Road Safety Audit Review
Burpee Road @ Plank Road
Town of Bristol
July 2, 2008

Road Safety Audit Review

Review Report

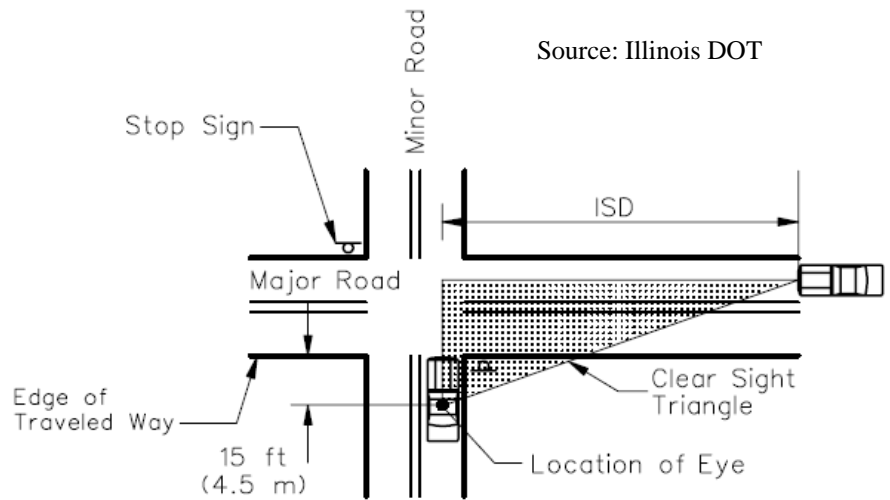
Problem:

Limited corner sight distance to the north when stopped on the east side of Plank Road

Immediate Actions:

Install a 24" stop bar four feet from the edge of Burpee Road

Short Term:

Promote a clear sight triangle as recommended by AASHTO

From the edge of the road, measure 15 ft back (this is the vertex of the sight triangle)

For an estimated traveling speed of 50 mph, "ISD" is 555 ft

For an estimated traveling speed of 40 mph, "ISD" is 445 ft

Anything within the triangle area such defined should be as much as possible removed

Work with the cemetery to have the stone pillar removed or relocated as it is an obstruction

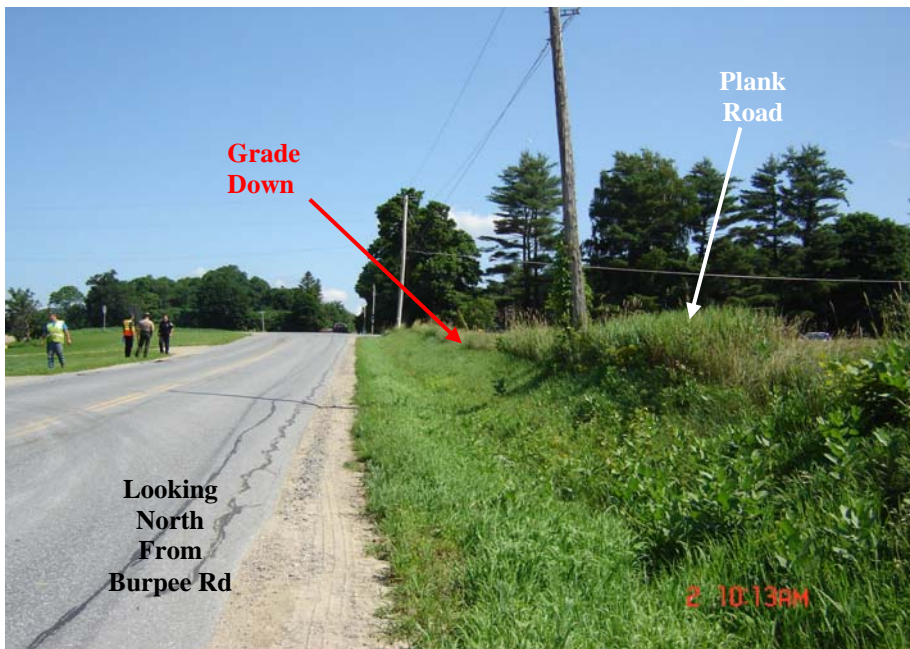
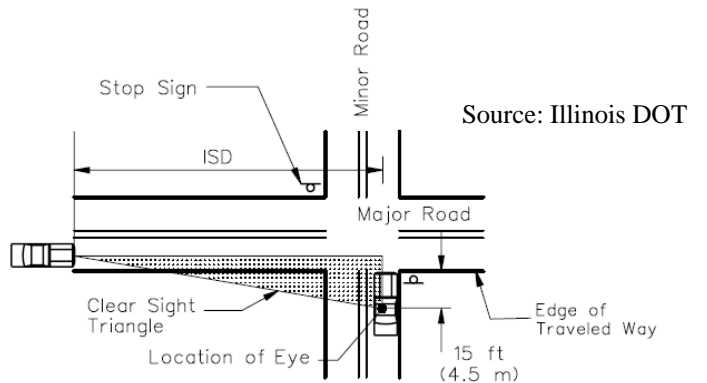
Problem:

Limited corner sight distance to the south when stopped on the west side of Plank Road

Short Term:

Define the sight triangle as previously explained

The utility pole is an obstruction. Work with the utility company to have it relocated

Grade down the berm

Work with the farmer to ensure that grass in the southeast corner is kept low

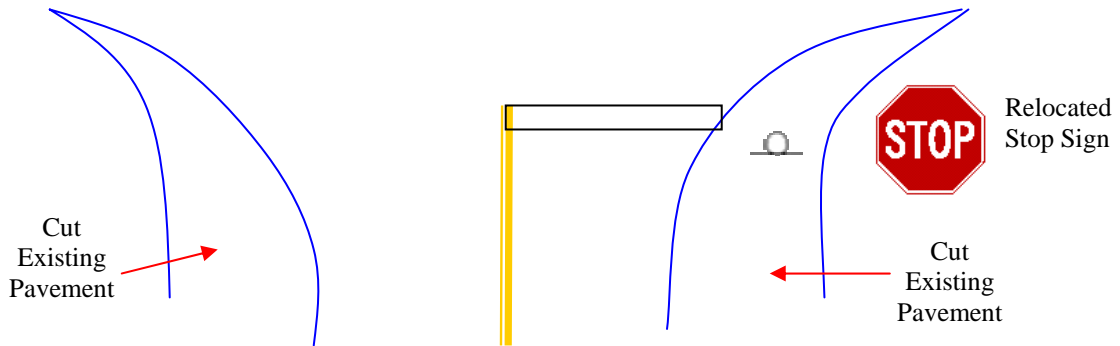
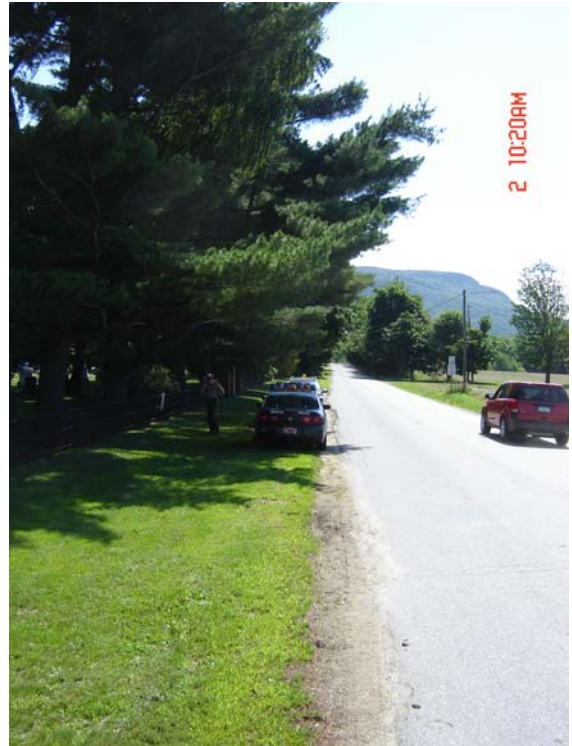
Problem:

Lack of definition of the Plank Road approach (east side)

Immediate Actions:

Install a 30" x 30" stop ahead sign (W3-1) in advance of the intersection

Short Term:

Narrow down the approach by removing some pavement on the corners and creating appropriate radii for trucks

Move up the stop sign (replace with new 30" x 30" R1-1) closer to the intersection in the area where pavement was removed

Installed about 30 ft of double yellow centerline

Install a stop bar four feet from

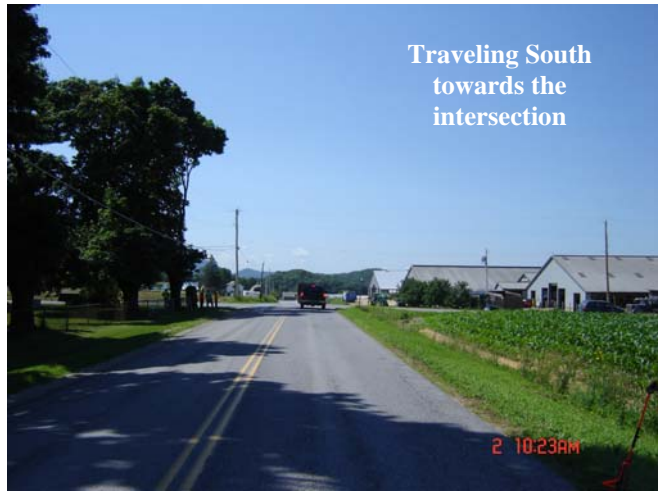
Problem:

Lack of conspicuity of the intersection when traveling on Burpee Road

Immediate Actions:

Replace the existing street name signs with new 9-inch blade ones (6-inch letters, D3-1)

In both directions, add a 36" x 36" four-way intersection sign (W2-1) with a Plank Road street name plaque underneath (W16-8). Use type IX fluorescent yellow sheeting. Install on two posts

Short Term:

Work with the cemetery to have the lower tree limbs pruned
